SSD 61400212
AB7 (P&E)

STATE SIGNIFICANT DEVELOPMENT APPLICATION 61400212
APPLICANTS: Third.i Crows Nest Residential Developments Pty Ltd

I refer to the recent public exhibition of the application and advise that following a review of the documents provided, Council objects to the approval of this development proposal.

Figure 1. Approved concept design – Dec 2020 (highlights added)

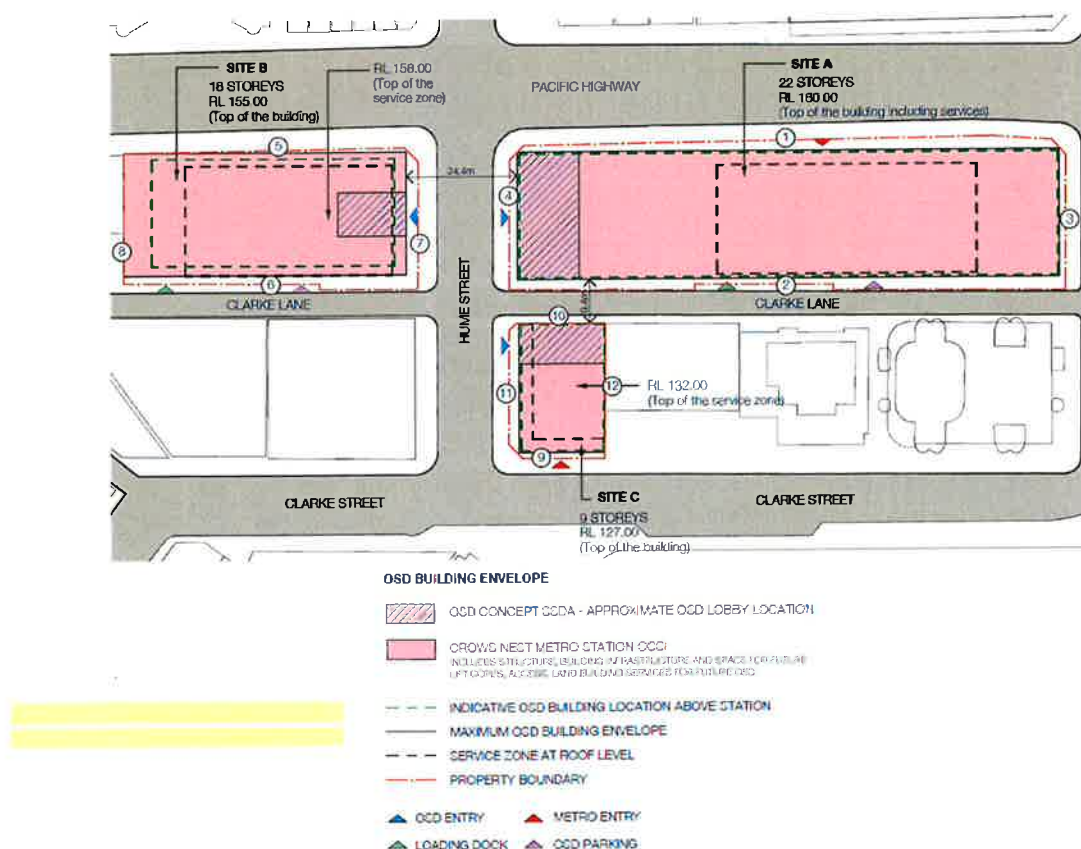
The approved building envelope diagrams from December 2020 include two sets of OSD building outlines: the maximum building envelope and the indicative OSD building location above the station. For Site B, the indicative OSD features a smaller floorplate with above podium setbacks provided along all property boundaries (Figures 2 and 3). The purpose of the two building outline controls is to ensure an appropriate level of articulation to the tower to improve the internal amenity of the residences, retain a better sense of scale at pedestrian level along the Pacific Highway and better reflect the fine grain context of Crows Nest village.

In contrast, the proposed tower fills the maximum approved building envelope, with limited above podium street and lane setbacks and minor articulation (Table 2). This results in a bulkier building that will contribute towards a 'canyon of towers' along the Pacific Highway, having regard to the increased tower heights under the Crows Nest TOD (see Section 2 of this advice).

Figure 3. Comparison of maximum proposed building heights under the 2036 Plan and Crows Nest TOD

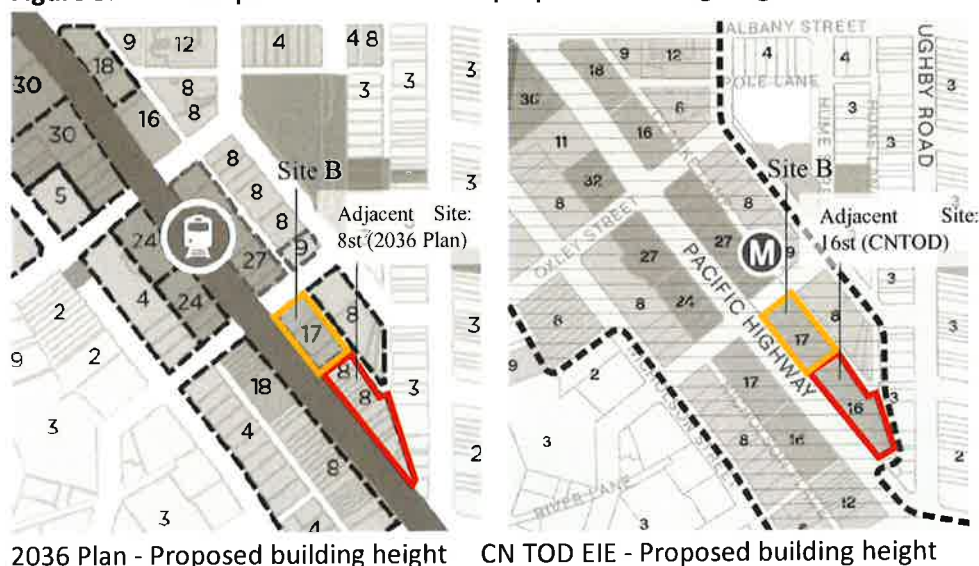
The 2036 Plan (NSW Government 2020) recommended a maximum building height of **8 storeys** for the sites adjacent to Site B to the south (Figure 4). To comply with the Apartment Design Guide (ADG), a total building separation of 21m is recommended between habitable rooms, comprising a 12m setback from Site B and a 9m setback from the adjacent site.

However, the recently published Crows Nest TOD increases the building height for the adjacent site from 8 storeys to **16 storeys** (Figure 4). This change requires a considerably more careful response to the ADG, which

recommends a total building separation of 24m between habitable rooms (12m setbacks from each side of the property boundary) for buildings above 8 storeys. Further, it is worth noting the Urban Design Report (SJB 2024) that underpins the Crows Nest TOD, recommends maximising tower separation with distances of up to 40m (Figure 5).

Figure 5. Limited tower separation distances being sought by the applicant in context with increased building heights proposed under the Crows Nest TOD

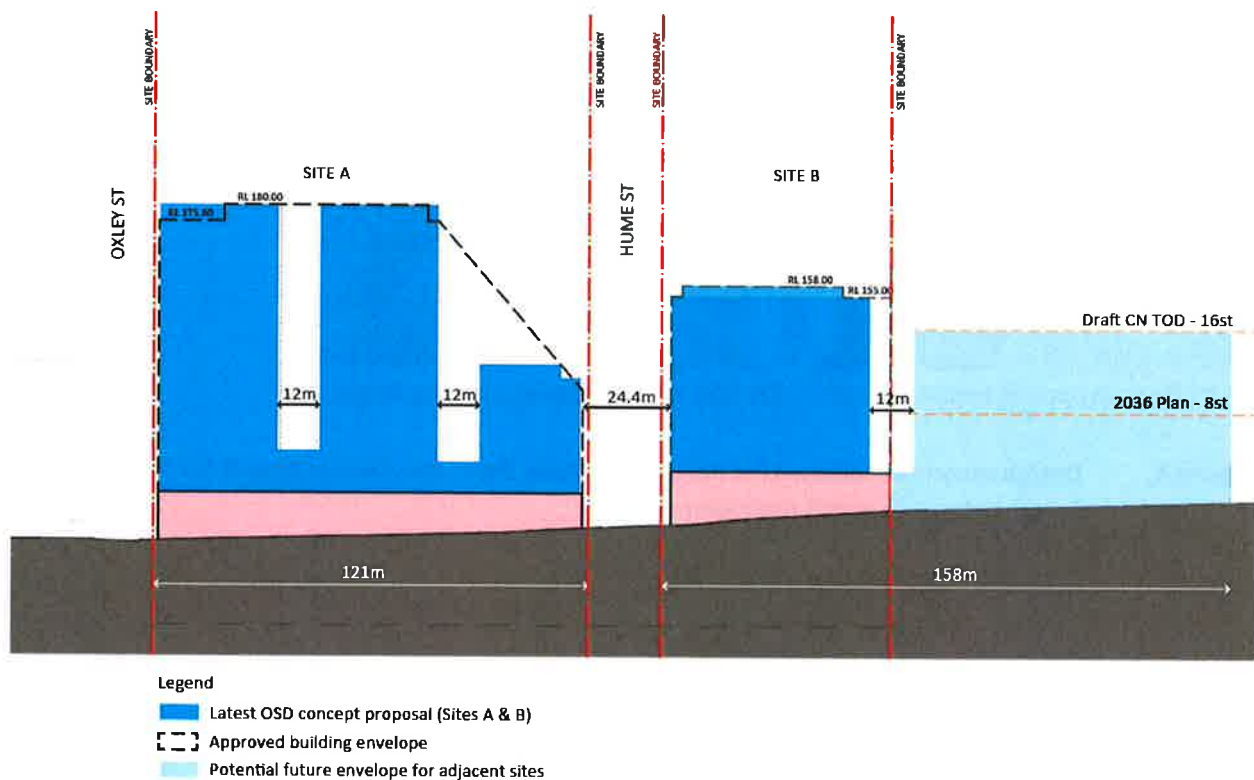
The proposed Site B building provides a setback of approximately 5–6.285m from habitable rooms to the southern site boundary for level 9-18, falling considerably short of the accepted minimum 12m setback requirement under the ADG and design recommendations of the Crows Nest TOD.

The cumulative effect of poorly separated tall buildings along the eastern side of the Pacific Highway, raises several significant concerns. The anticipated massing will be highly visible from local viewpoints, including Ernest Place, Hume Street Park, Willoughby Road, and the Pacific Highway. Lack of any meaningful gaps or articulation between buildings (Figure 5) will cause a 'wall effect' when looking up or down the highway or from the centre of Crows Nest. It will also cause significant afternoon overshadowing of Ernest Place and Willoughby Road during spring and autumn equinoxes.

To mitigate these impacts and provide adequate amenity to the residential units, it is recommended that a minimum 12m building setback be provided by Site B along the shared southern boundary.

Figure 6. Proposed open air above ground car parking level of Site B with nil setback to the south

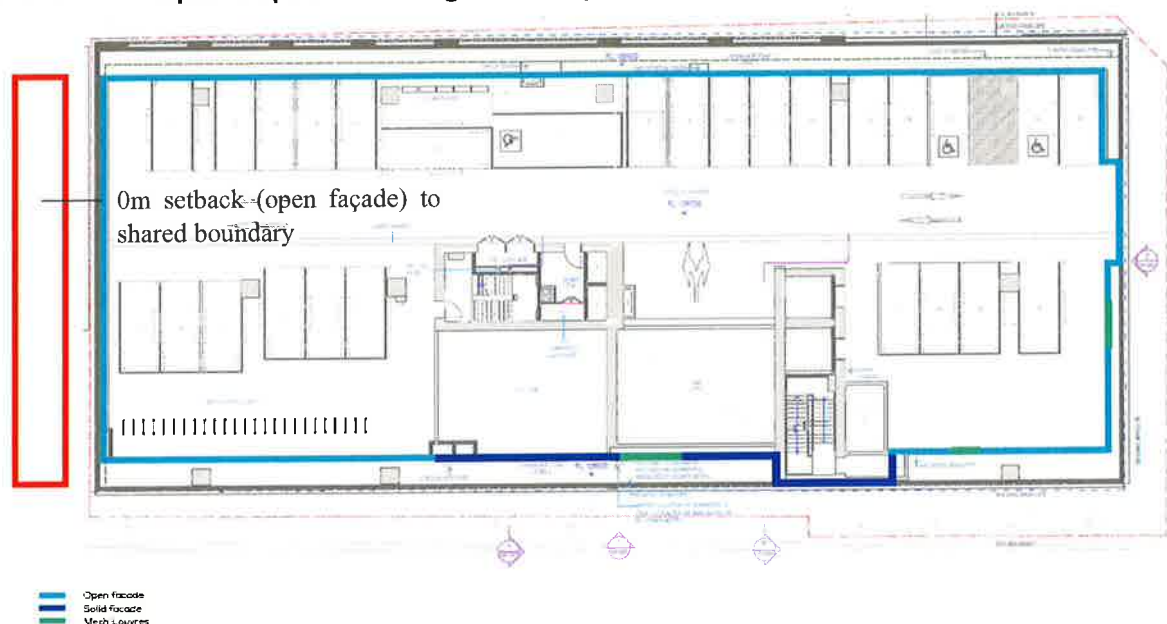
The proposed building includes two levels of car parking on Levels 5 and 6, with a direct open interface to the adjacent site to the south and a 0m setback to the shared boundary (Figure 7). The façade at this interface is designed as an open structure, featuring perforated metal panels.

This design raises significant concerns, as it would have a detrimental impact on the residential amenity of the adjacent site, particularly in terms of privacy, noise, air quality and visual intrusion.
